**BEFORE THE PUBLIC UTILITIES COMMISSION OF THE
STATE OF CALIFORNIA**

In the Matter of the Application of) Application No. 07-04-028
SOUTHERN CALIFORNIA EDISON)
COMPANY (U338E) for a Permit to) (Filed April 30, 2007)
Construct Electrical Facilities with Voltages)
between 50 kV and 200 kV:)
Fogarty Substation Project.)

In the Matter of the Application of) Application No. 07-01-031
SOUTHERN CALIFORNIA EDISON)
COMPANY (U338E) for a Permit to) (Filed January 16, 2007)
Construct Electrical Facilities with Voltages)
between 50 kV and 200 kV:)
Valley-Ivyglen 115 kV Subtransmission Line)
Project)

PROJECT MODIFICATION REPORT
SOUTHERN CALIFORNIA EDISON COMPANY (U 338-E) PETITION FOR
MODIFICATION OF DECISION 10-08-009

Figure 2-1: Valley-Ivyglen 115 kV Subtransmission Line Overview Map

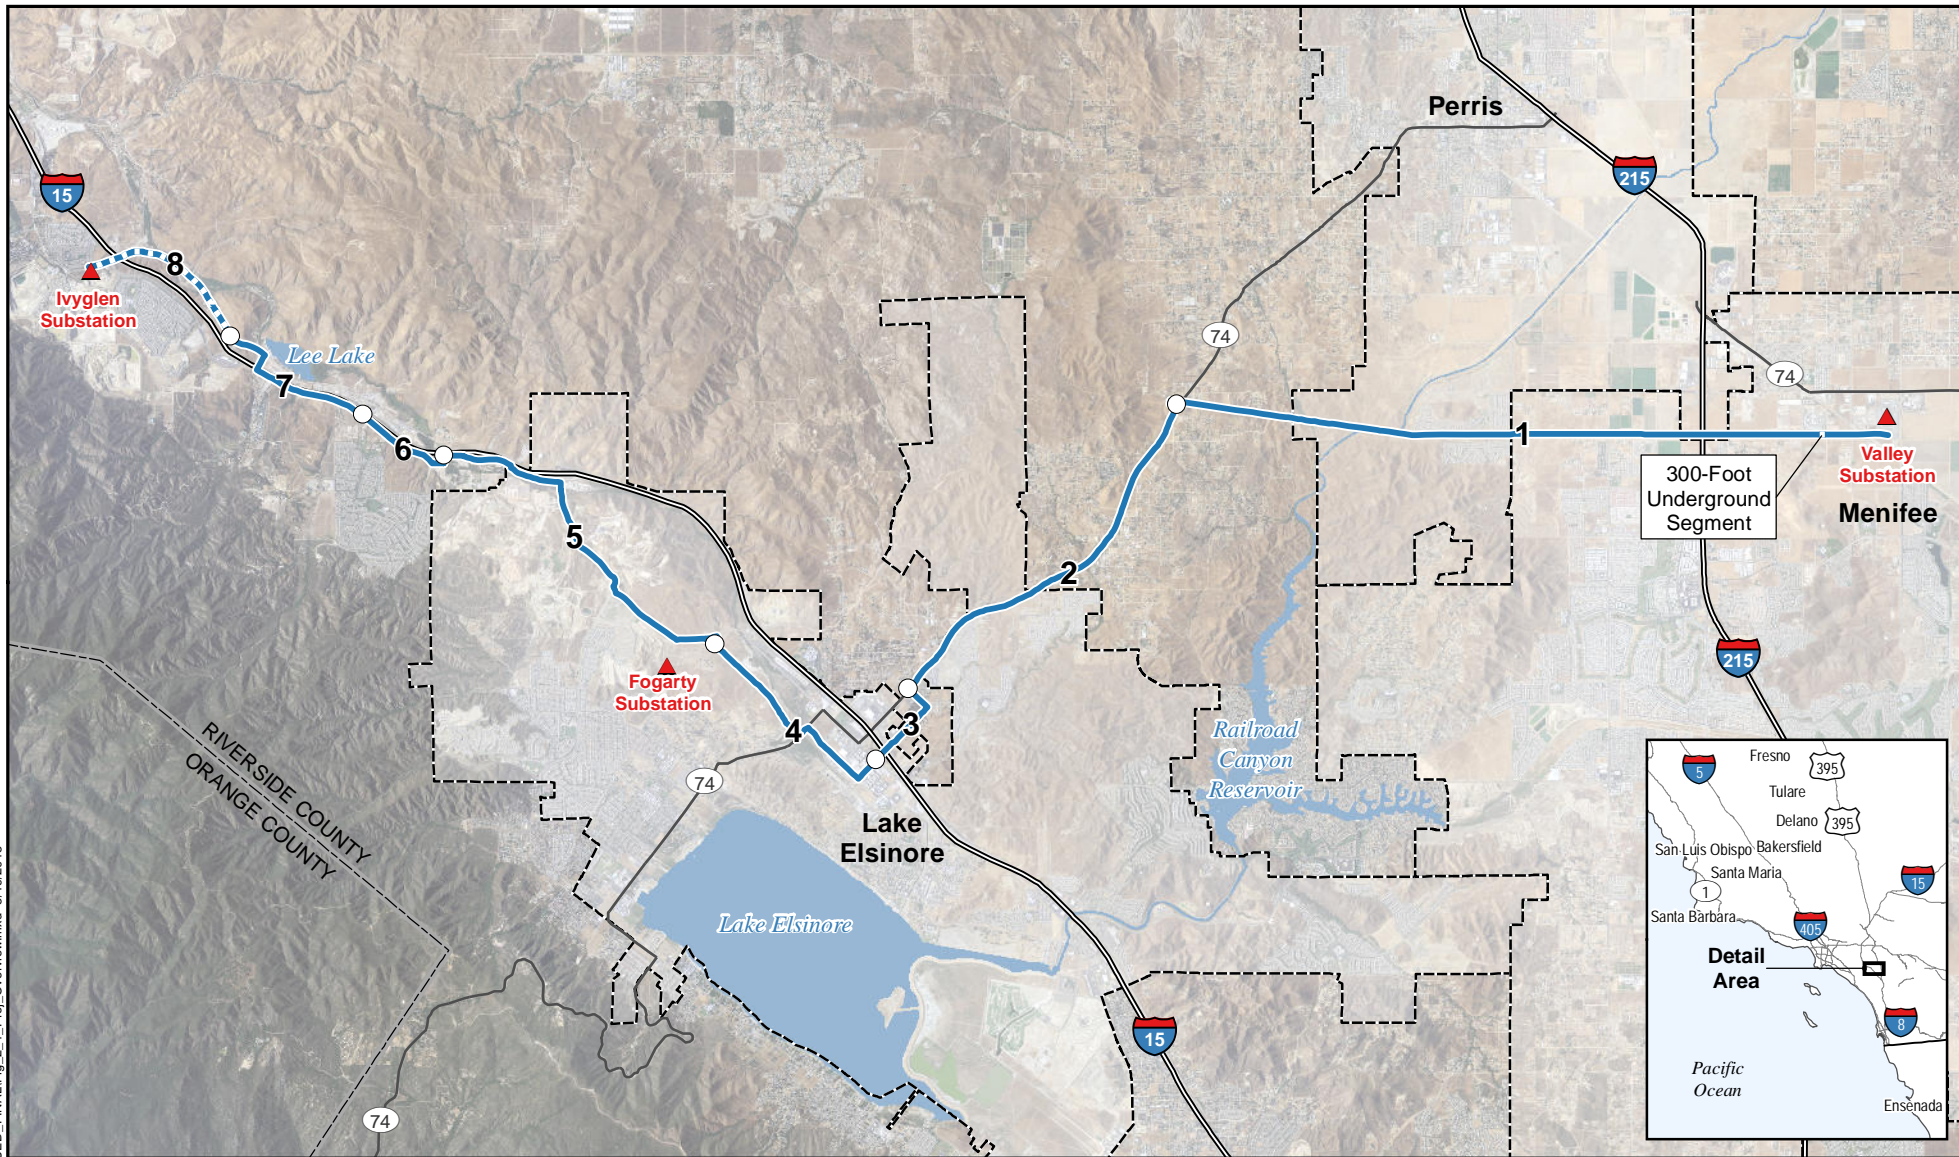
The following subsections describe the locations where the Proposed Modifications segments would be realigned. *Figure 2-1: Valley-Ivyglen 115 kV Subtransmission Line Overview Map* and *Attachment 2-A: Detailed Route Map* provide the location of the Valley-Ivyglen 115 kV Subtransmission Line realignments.

SCE is proposing to install portions of Segments 1 and 8 underground. Segment 1 would be installed underground in order to cross under an existing 500 kV overhead transmission line that connects Inland Empire Energy Center to Valley Substation. As described previously, Segment 8 would be relocated and installed underground to avoid impacts to jurisdictional drainages and potential landslide hazards between I-15 and Temescal Canyon Road. The following subsections describe the locations where the Proposed Modifications segments would be installed underground.

Figure 2-2: Hybrid Pole Typical Drawing

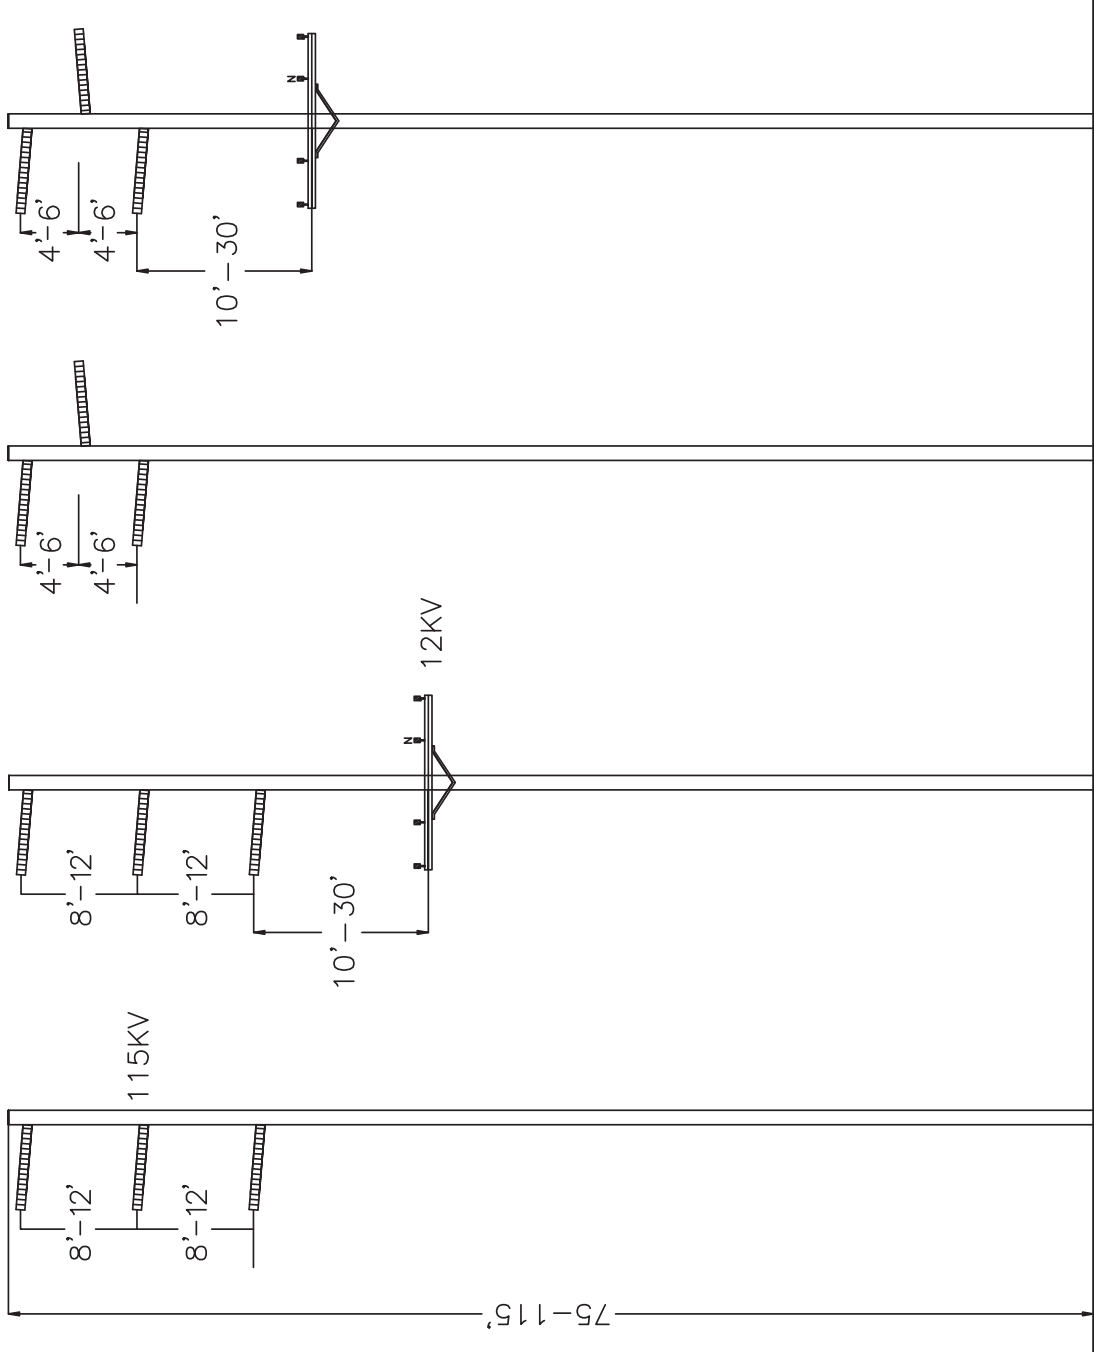
Further refinement of the Proposed Modifications design has required the use of three additional types of poles—hybrid poles, wood poles, and guy poles. *Figure 2-2: Hybrid Pole Typical Drawing*, *Figure 2-3: Wood Pole Typical Drawing*, and *Figure 2-4: Guy Pole Typical Drawing* depict typical views of these additional pole types, although the actual design may slightly deviate from the views depicted.

Figure 2-5: Underground Duct Bank Typical Drawing

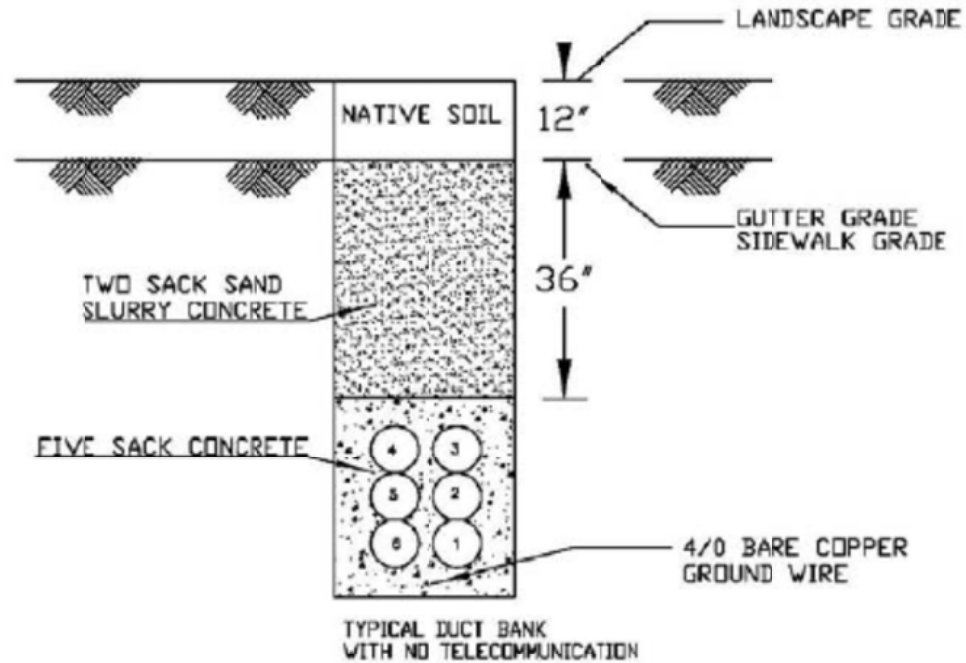
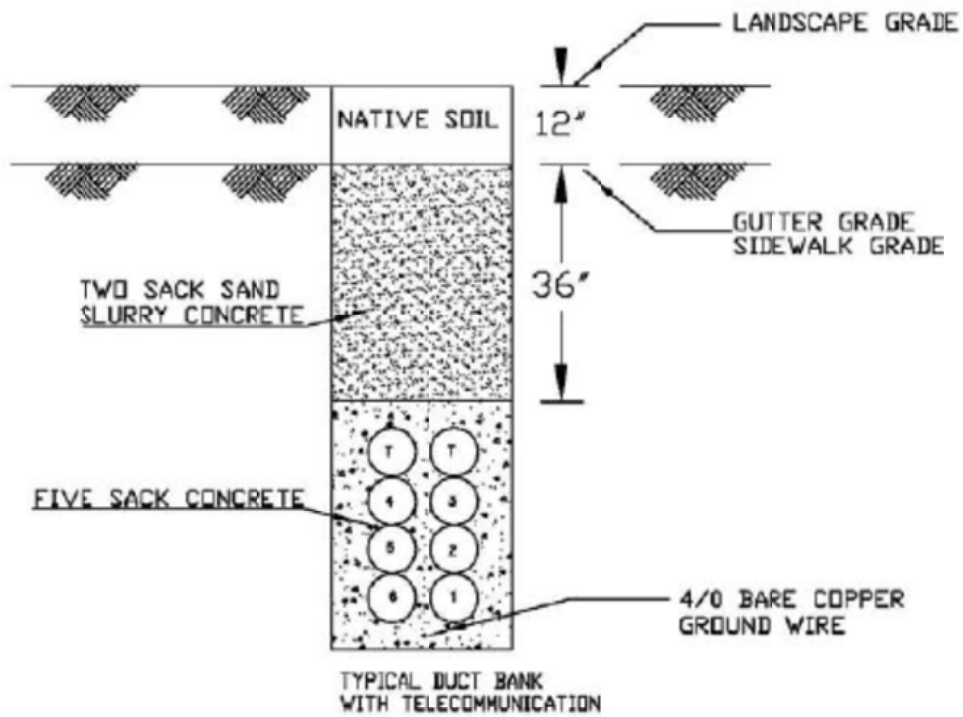
As trenching for the underground 115 kV subtransmission line is completed, SCE would begin to install the underground duct bank. Collectively, the duct bank is comprised of cable conduit, spacers, ground wire, and concrete encasement. The duct bank typically consists of six approximately six-inch-diameter polyvinyl chloride (PVC) conduits fully encased with a minimum of three inches of concrete all around. Typical 115 kV subtransmission duct bank installations would accommodate six cables. The Proposed Modifications would utilize three cable conduits and leave three spare cable conduits for any potential future circuit pursuant to SCE's current standards for 115 kV underground construction. *Figure 2-5: Underground Duct Bank Typical Drawing* provides a typical drawing for standard duct bank configuration.

The majority of the duct banks would be installed in a vertically stacked configuration and each duct bank would be approximately 21 inches high by 20 inches wide. In areas where underground utilities are highly congested, or in areas where it is necessary to fan out the conduits to reach termination structures, a flat configuration duct bank may be required. However, it is not anticipated that a flat underground duct bank configuration would be required for the Proposed Modifications.

Figure 2-6: Riser Pole Typical Drawing

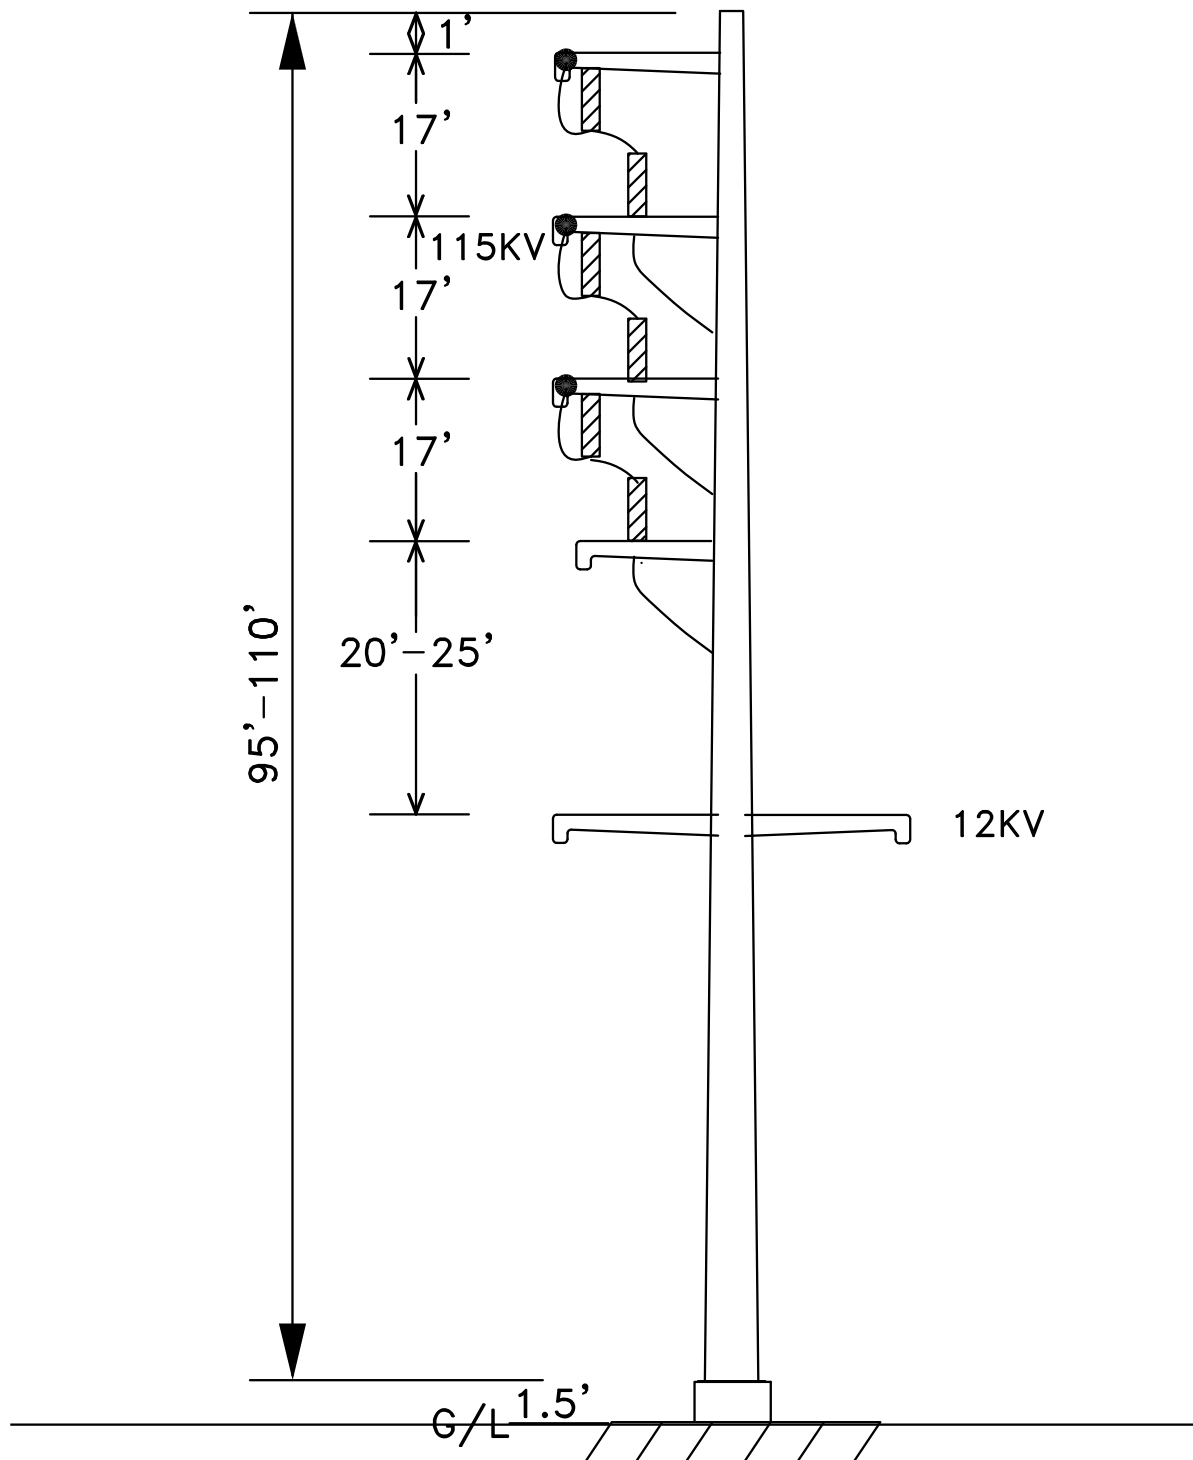
At each end of an underground segment, the cables would rise out of the ground at riser poles, which accommodate the transition from underground to overhead subtransmission lines. Riser poles constructed as part of the Proposed Modifications would consist of engineered TSP structures. The riser pole would support cable terminations, lightning arresters, and dead-end hardware for overhead conductors. *Figure 2-6: Riser Pole Typical Drawing* provides a typical drawing of riser poles. Construction methods for these structures would be substantially similar to those described for TSP installation in the Final EIR.

Figure 2-7: Telecommunications System Overview Map

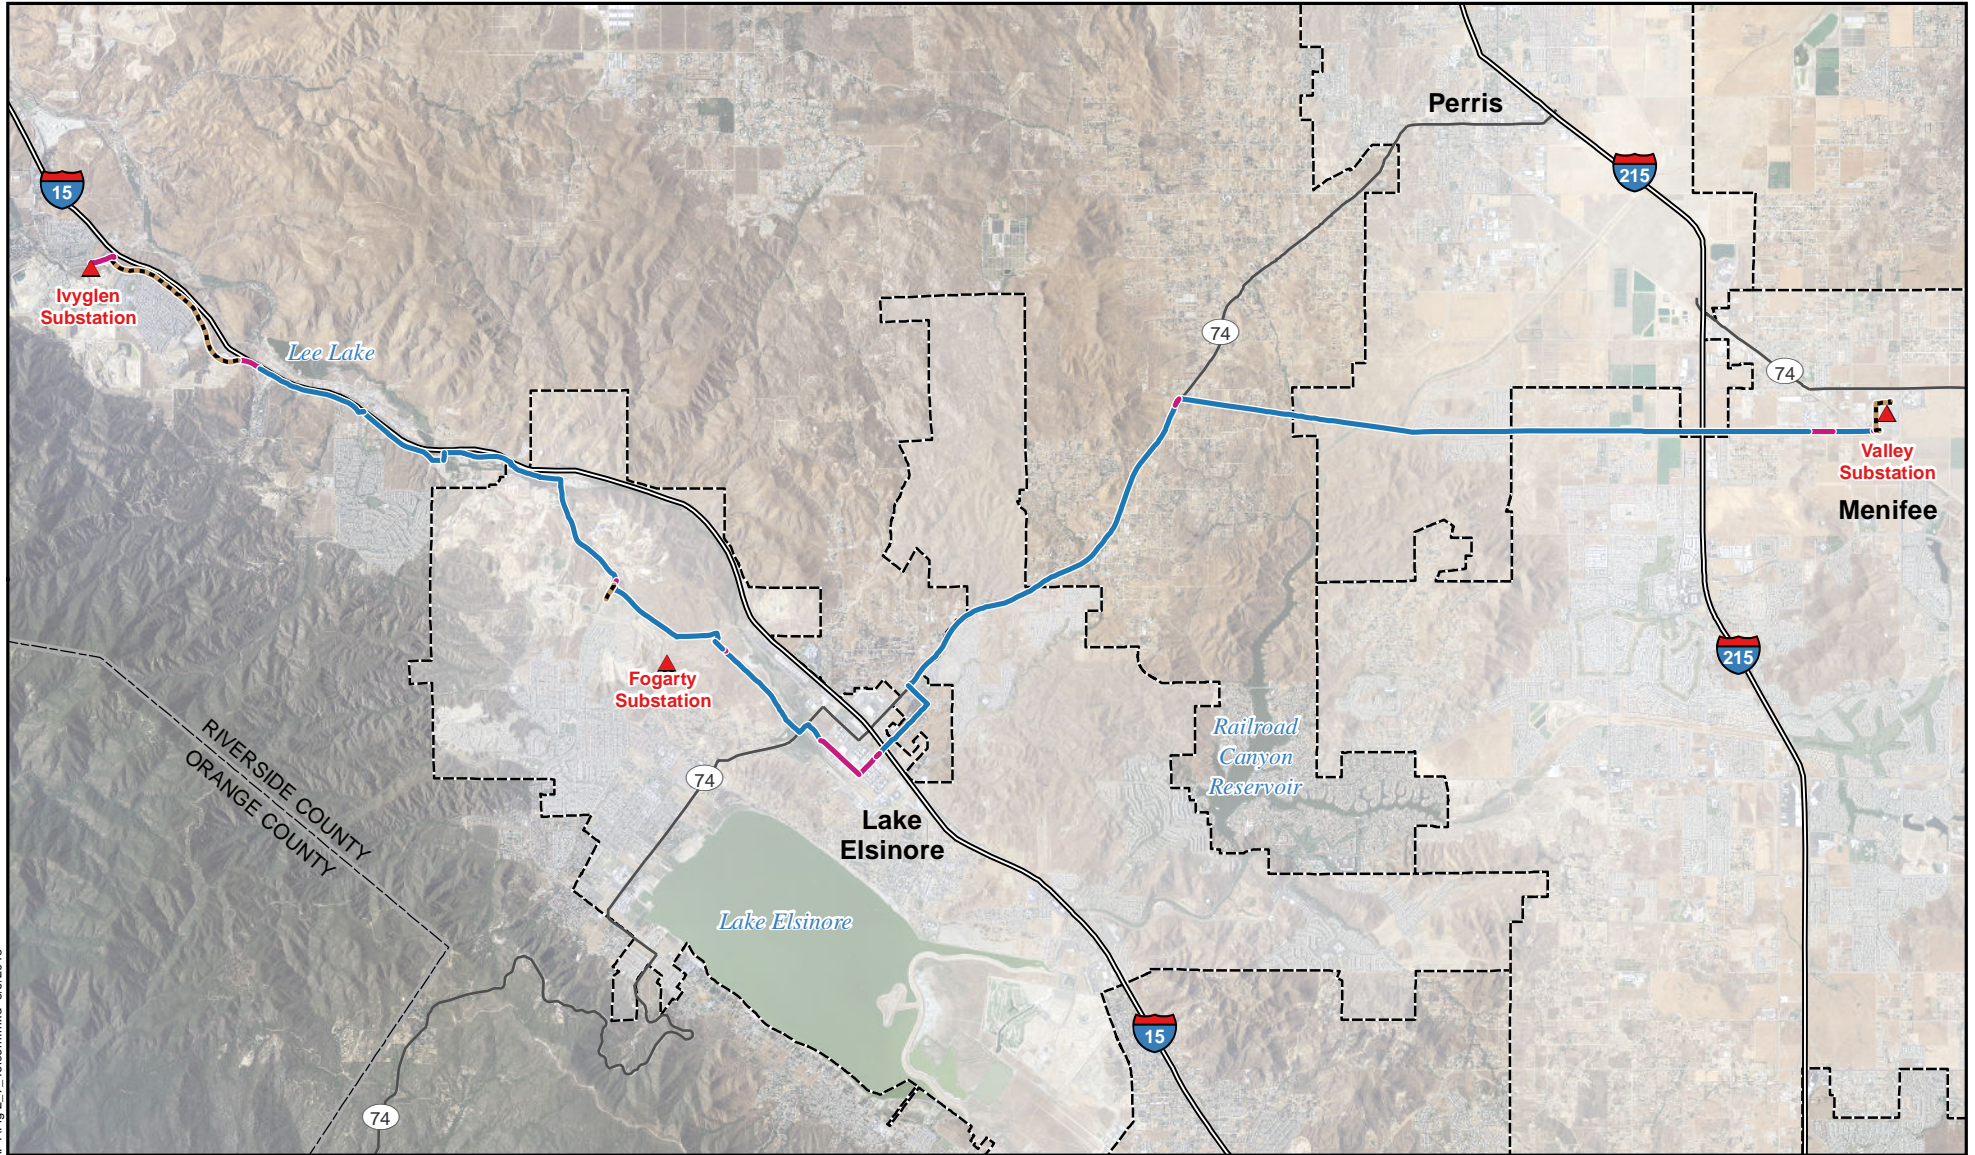
The following subsections describe the locations where the Proposed Modifications would be installed underground. These locations are summarized in *Table 2-4: Underground Fiber Optic Cable Installation Summary* and illustrated in *Figure 2-7: Telecommunications System Overview Map*.
